Sea Link

Document 9.86 Applicant's Comments on Other Submissions Received at Deadlines 3 and 3A

Planning Inspectorate Reference: EN20026

Version: BA
February 2026

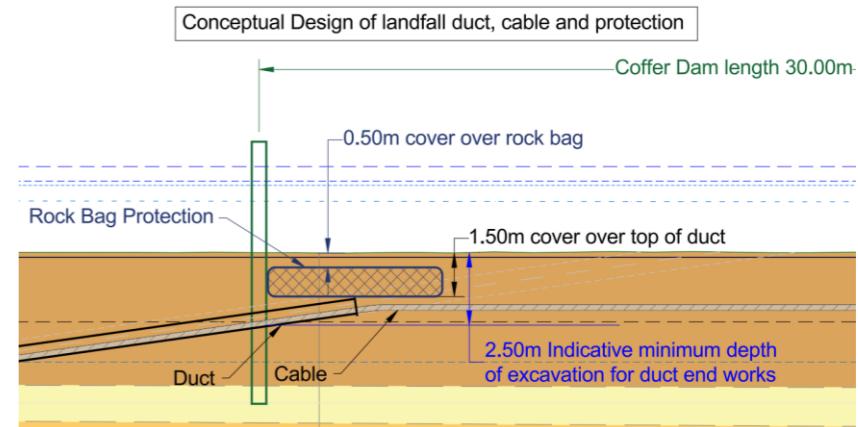
5 1.9.23	Natural England notes that the WCS cofferdam parameters at each HDD exit pit are as follows: 10-15 m in length, 3-5 m width, and 2 m depth below seabed level. However, in [REP1-108] it is stated that the assessed WCS assumes the construction of smaller cofferdams (maximum length 30m, width 5m, piling depth approx. 6m below ground level and 2m excavation depth within the cofferdams) on four separate occasions. Therefore, we remain concerned, that the increased WCS cofferdam size represents an increase not only in intertidal sediment disturbance, but also blockage potential, which could modify waves and/or current flows around the structure, affecting sediment transport, and leading to morphological change.	Natural England advises that the EIA should be updated accordingly, taking into account the larger cofferdam size proposed, seabed disturbance area and volume, blockage potential, and scour potential. Duration and timing of the cofferdam installation and presence should be taken into account.	<p>Application Document 9.13 (B) Pegwell Bay Construction Method Technical Note [REP2-011] explains that:</p> <p>The assessed worst-case scenario assumes the construction of smaller cofferdams (maximum length 30 m, width 5 m, with piling depth approximately 6 m below ground level and excavation depth within the cofferdams to a depth below seabed of 2 m) on four separate occasions during HDD drilling and duct installation. Based on previous works, it is anticipated it will take up to seven days to install a cofferdam around a single HDD exit pit. Only one cofferdam will be installed at any one time, and while the total duration for all cofferdams in place is 120 days, each cofferdam is expected to be in place for only 30 to 60 days. Therefore, any impact will be temporary.</p> <p>(Application Document 9.13 Pegwell Bay Construction Method Technical Note [REP2-011]).</p>

Ref Section / Para	Key Concern and/or Update	Natural England's Advice to Resolve Issue	Applicant's Comments
			<p>The cofferdams will be located essentially at Mean Sea Level (MSL) (0.20 m OD elevation, MSL is approximately 0.15 m OD. Therefore, for 50% of the time the area surrounding the cofferdam will be dry and no scour will be taking place. Further, Application Document 9.20.2 Landfall Sediment Modelling Report Pegwell Bay [PDA-038], explains that peak current velocities in Pegwell Bay are less than 0.1 m/s, which is well below the flow rates associated with any significant scour depths.</p> <p>On this basis and taking into account the larger cofferdam dimensions than previously considered, the magnitude of any change in relation to the cofferdam on nearshore seabed morphology (and the associated flow dynamics) will be small. This results in a minor effect which is not significant.</p> <p>Application Document 6.2.4.1 Part 4 Marine Chapter 1 Physical Environment has been submitted at Deadline 4.</p>

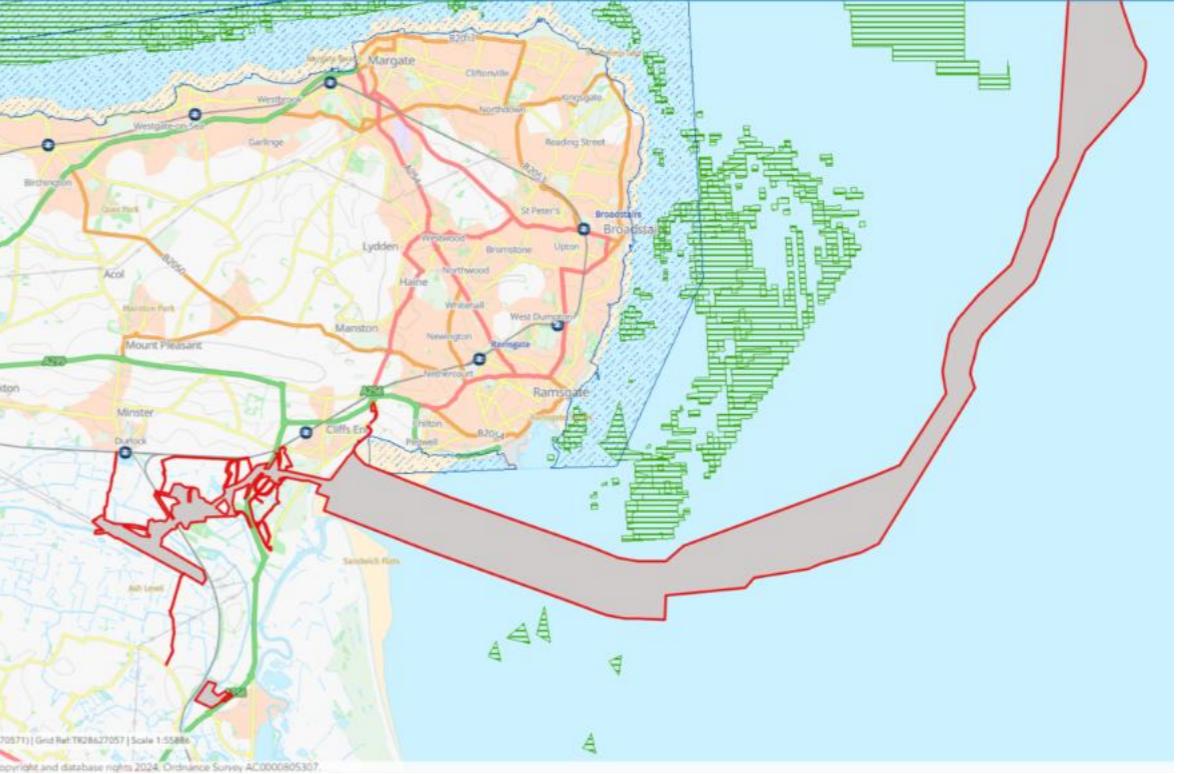
2	5.7.2	<p>Natural England notes a preference for <i>Sabellaria spinulosa</i> reef assessments to follow the approach as set out by Gubbay (2007) and Jenkins et al. (2018), rather than the split approach set by Collins (2010) used by this survey report. This concurs with Natural England's best practice advice (Parker et al. 2025a).</p>	<p>Please see above comments on determining reefiness.</p> <p>This 2025 Parker guidance was not available at the time of the surveys being undertaken (e.g. 2021-2024) or at the time of analysis or writing.</p> <p>In recognition of such sensitive habitats, the Applicant has made commitment BE06 in the REAC (Application Document 9.84 Register of Environmental Actions and Commitments (REAC) [REP3-078]) that where benthic habitats of principal importance are identified during pre-construction surveys and mitigation is required to avoid or reduce impacts on these habitats, an In-Principle Monitoring Plan (IPMP) will be prepared in consultation with the MMO and SNCBs to verify the accuracy of predicted residual impacts on these habitats.</p> <p>The new best practice advice (Parker et al., 2025a) will be used in the assessment of <i>Sabellaria spinulosa</i> reef based on data collected during the pre-construction surveys and consultation with Natural England will be undertaken to agree the habitat assessment methods.</p>

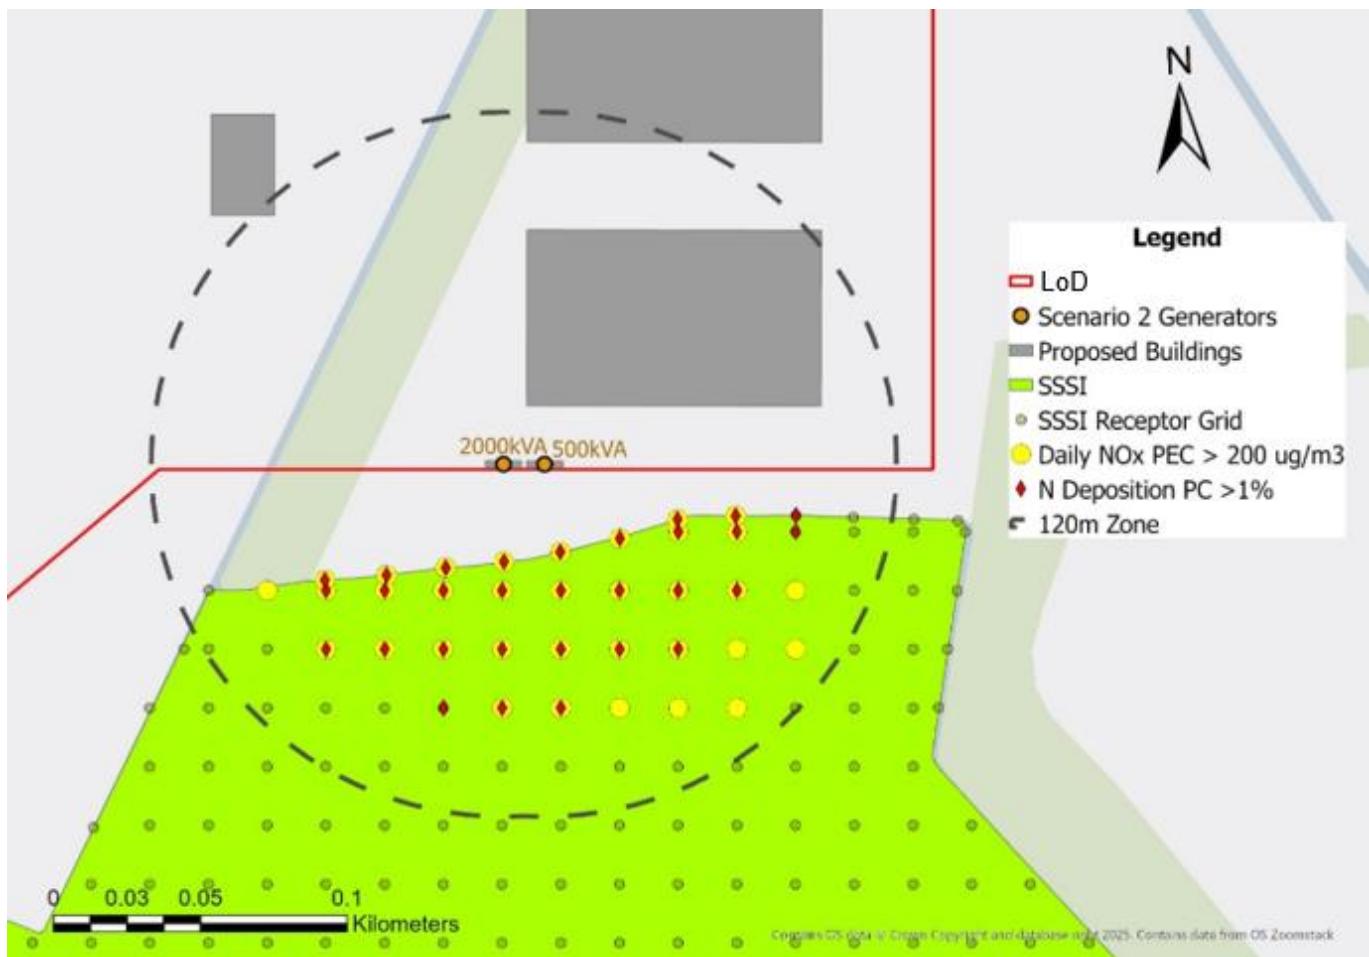
- A.7.44 The maximum impact of the generator emissions at each SSSI receptor point (across all five meteorological years) is presented in **Appendix Table A.9 Scenario 2 Worst-Case Design - Full Receptor Grid Results**. **Appendix Table A.7 Maximum Impact on SSSI in Scenario 2** presents the maximum impact modelled anywhere in the SSSI. It should be noted that background NO_x and N deposition do not change across the receptor grid, and so the PEC is always largest at the receptor point where the largest PC occurs.

- A.7.48 The results show that if both generators were positioned close to the SSSI then there would be potential for significant air quality effects on the SSSI. The receptor grid for the SSSI has been used to determine how far from the generators there could be potentially significant effects. **Appendix Plate A.2 Area of Modelled Exceedance of Thresholds** shows the grid points where exceedances of the daily mean NOx critical level are predicted (Daily NOx PEC $> 200 \text{ ug/m}^3$), and where the N deposition PC exceeds the 1% critical load for N deposition.

- A.7.49 The results show that the area of potential significant effects extends up to approximately 100 m from the generators, and so if the generators were positioned at least 120 m from the SSSI, there should be no significant effects. A 120 m zone around the generators is also presented in **Appendix Plate A.2 Area of Modelled Exceedance of Thresholds**, to help demonstrate this, as it shows there are no threshold exceedances within this area. This is also partly demonstrated by Scenario 1, as both generators are located more than 120 m from the SSSI, and there are no potentially significant effects on the SSSI when considering the thresholds in **Appendix Table A.5 Thresholds for Potential Significant Effects**.
